CITY of NOVI CITY COUNCIL

Agenda Item 3
March 7, 2011

SUBJECT: Consideration of the request of Pi's Property Management, LLC, for Special Land Use Permit, Preliminary Site Plan and Storm Water Management Plan approval for Genji Japanese Steakhouse. The subject property is located in Section 15, at 27155 Sheraton Drive, west of Novi Road and north of I-96, in the C, Conference District, consisting of approximately 5.79 acres. The applicant is proposing additions and façade modifications to the existing restaurant building, and modifications to the parking lot and landscaping.

SP10-47A Genji Japanese Steakhouse

Attachment (detail for standard island design)

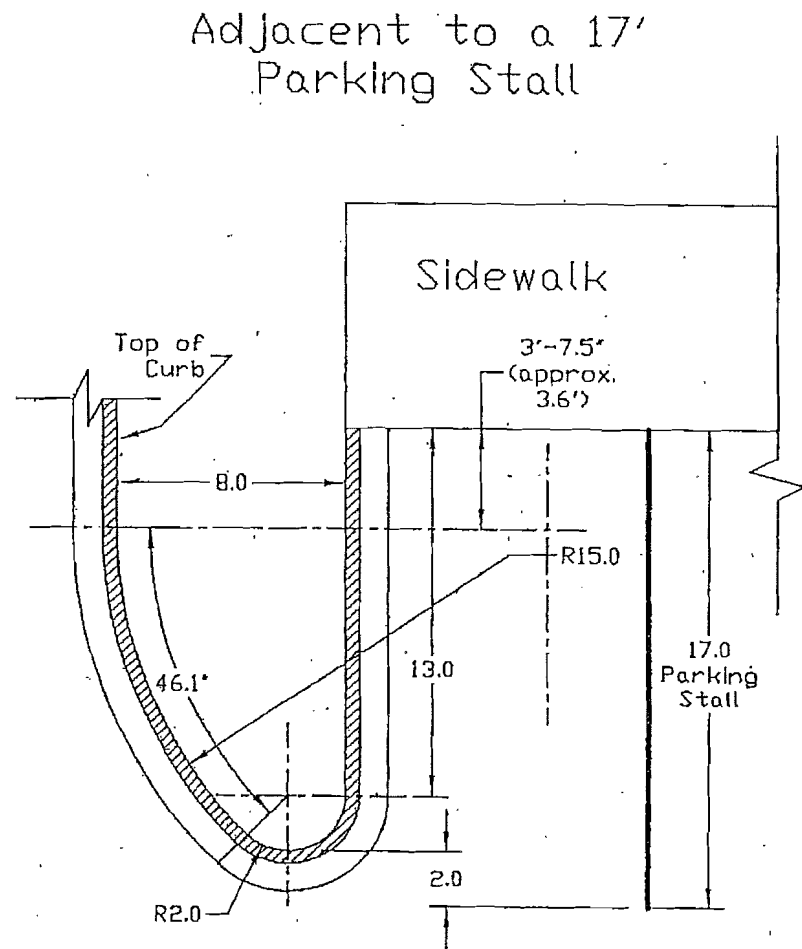
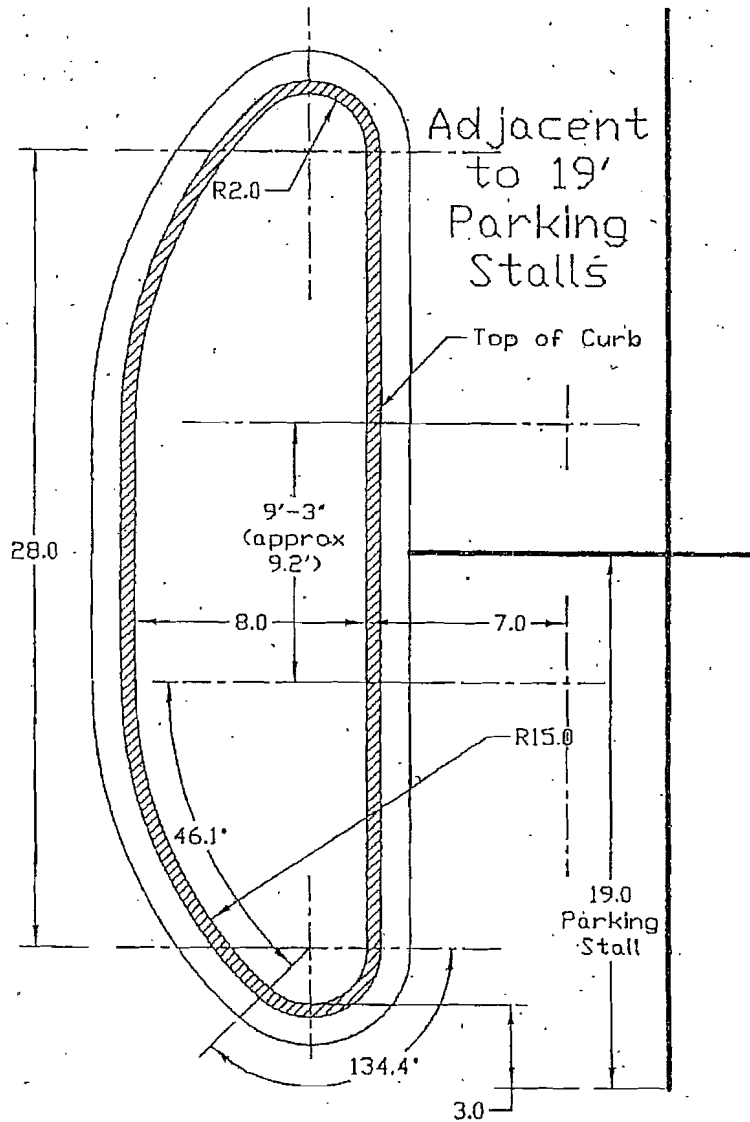
6. The existing north drive appears to have design dimensions within acceptable ranges per DCS Figure IX.1 (i.e., a 25-ft width and return radii of 15-20 ft). At our request, a 24-inch STOP (R1-1) sign will be added on the driveway's approach to Sheraton Drive. **The note on engineering sheet 2 should be revised to indicate that this STOP sign will be mounted on the existing "light" pole, not "power" pole.**

7. The existing south drive appears to be only about 19 ft wide, or 1 ft narrower than permitted by DCS Figure IX.1. This drive has previously served a similar use on the site, and will likely serve a relatively small fraction of the site's total traffic. **The requested 24-inch STOP (R1-1) sign exiting this driveway, shown on the initial preliminary site plan, is not shown on this revised plan and should be restored as a proposed improvement (in the Traffic Control Sign Table as well in the location where it will be installed). The Sign Table should indicate that both STOP signs will be the 24-inch size (permitted for low-speed applications).**

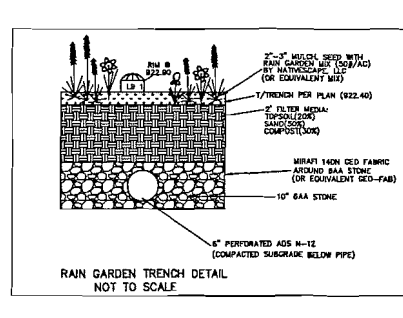
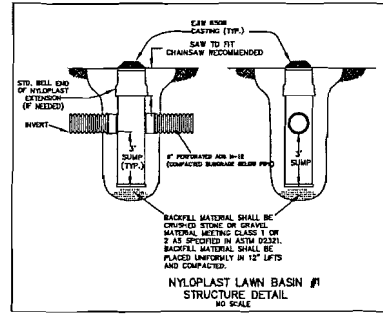
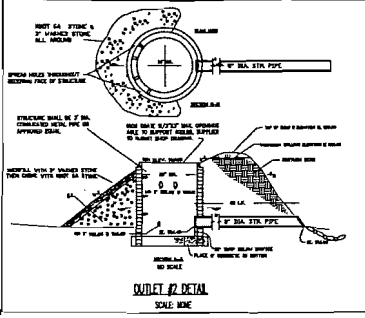
10. Provide calculations as required in the Engineering Design Manual for the bioretention basin.
11. The structure numbering and labeling in calculations should be consistent and reflected in the plan for catch basins and other structures.
12. Some coefficients used for the drainage calculations seem lower than the minimums allowed in the Engineering Design Manual. Calculations supporting the weighted average should be added to the plans.
13. Revise Sheet 8 of 8 to improve legibility. Several details include text that is difficult to read.

13. Revise Sheet 8 of 8 to improve legibility. Several details include text that is difficult to read.

Sheet 8 will be updated to help improve the readability of the sheet. If necessary, an additional sheet will be provided to enlarge the information from sheet 8 on the final site plans.

FUTURE PLAN WITH LANDBANKED SPACES

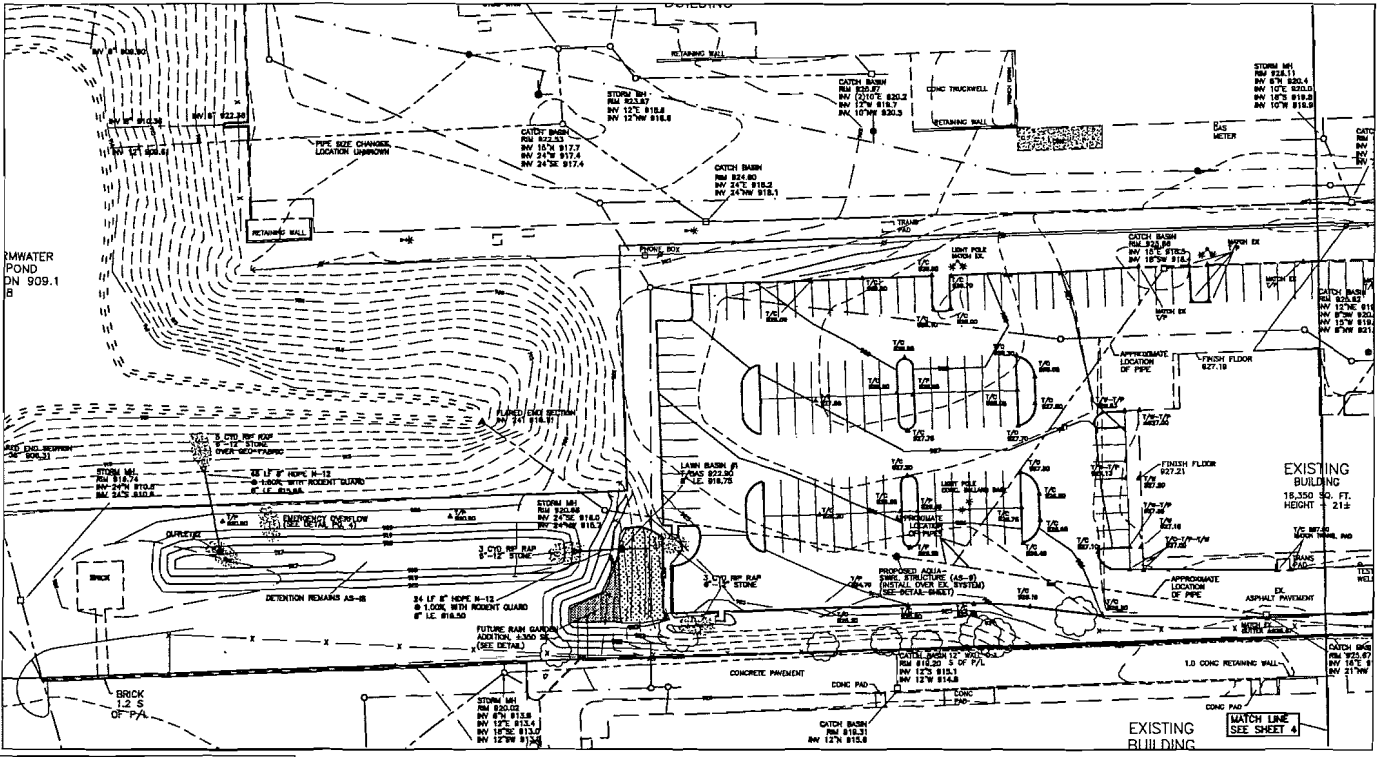
The Site Plan depicts 210 existing and proposed parking spaces and 41 landbanked parking spaces (251 total). The Plan also depicts 36 parking spaces as "by others" that could be relabeled as landbanked parking spaces. The applicant is asked to **provide at least 216 developed parking spaces and seek City Council approval for up to 48 landbanked parking spaces or provide additional justification to request additional landbanking of parking spaces.**
